| CHECKED <u>JB</u> | APPROVED JB | DRAWING NO. DSI 9244 | REV. A SHEET 1 OF 1 |
| DATE 02-12-19 | | TITLE DUAL BATTERY RACK | SCALE 1/4 |

REPAIR SCHEME

DART SERVICE INSTRUCTION

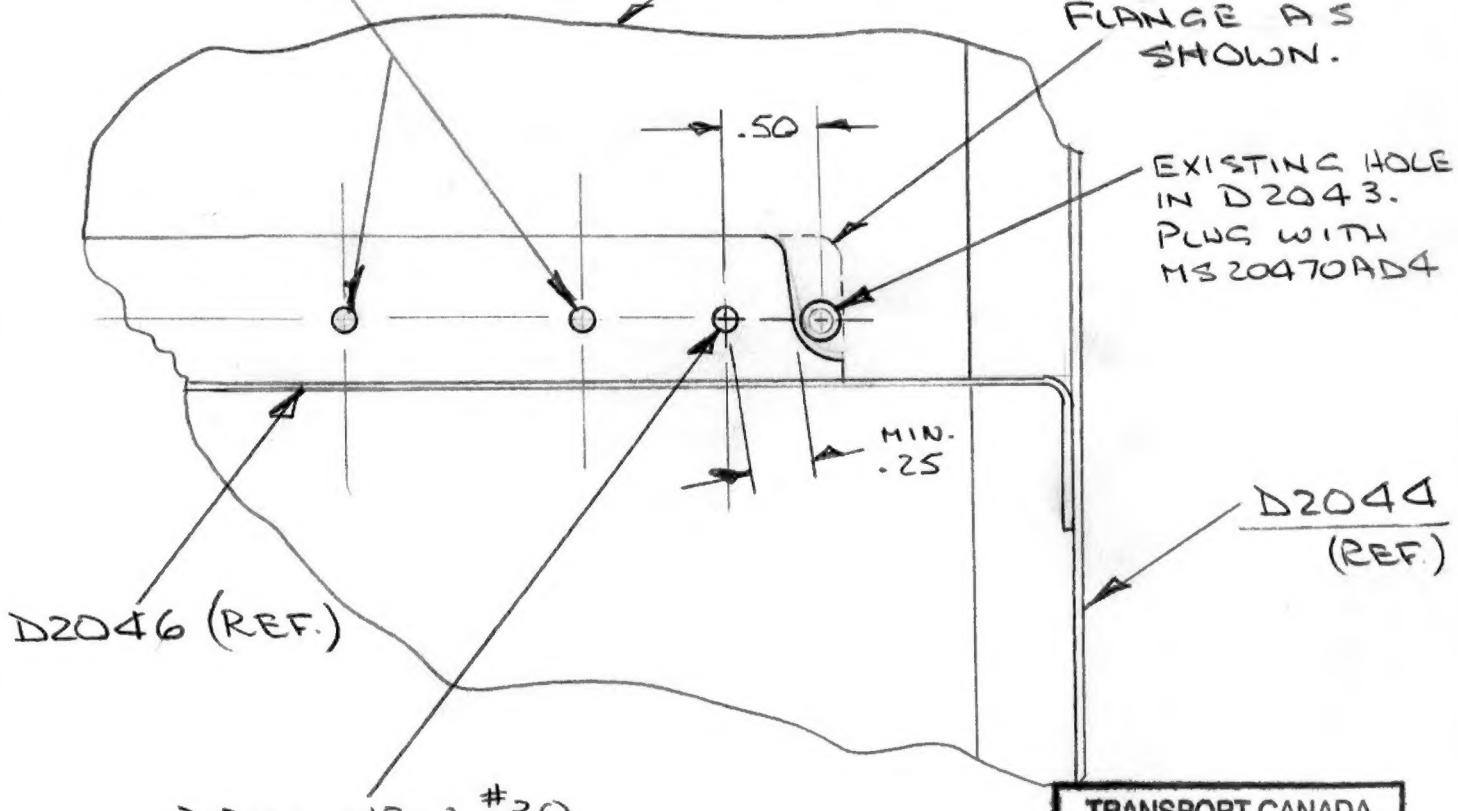
EXISTING RIVET HOLE IN
D2046 HAS INSUFFICIENT
EDGE DISTANCE.

TRIM D2046
FLANGE AS
SHOWN.

DRILL NEW #30
HOLE AS SHOWN
THROUGH D2046
AND D2043.

REPAIR AS SHOWN
